Hunter F.G.A. Mk. 9 Aircraft—Rotol Mod. No. GB.1109 (Introduction of Centrifugal Breather) Catered for

(Mod. No. Hunter/751.)

(AB/A/8189.—16.10.59.)

DRG. No. A.P. 4347U/S/1/59.

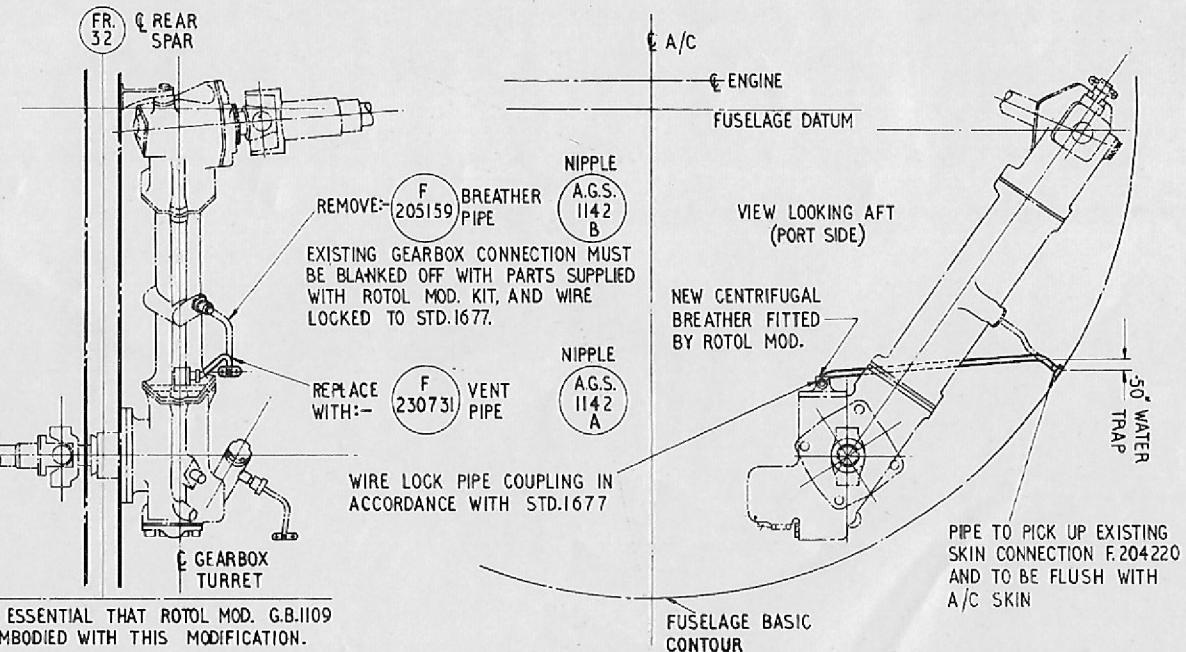
To prevent loss of oil, with consequent damage to the Gearbox Turret drive arm, Rotol Mod. No. G.B. 1109 (Introduction of Centrifugal breather) has been introduced. This necessitates repositioning the breather pipe on the Gearbox Turret drive arm.

- (1) Remove the gearbox turret access door.
- (2) Remove the Breather Pipe, Part No. F.205-159, together with Nipple, Part No. AGS.1142/B, from the drive arm of the accessory gearbox drive assembly, as shown on the Drawing.
- (3) Fit Vent Pipe, Part No. F.230731, together with Nipple, Part No. AGS.1142/A, as shown on the Drawing.

Note:— Pipe connection must be locked with 22 s.w.g. stainless steel wire, specn. D.T.D.189.
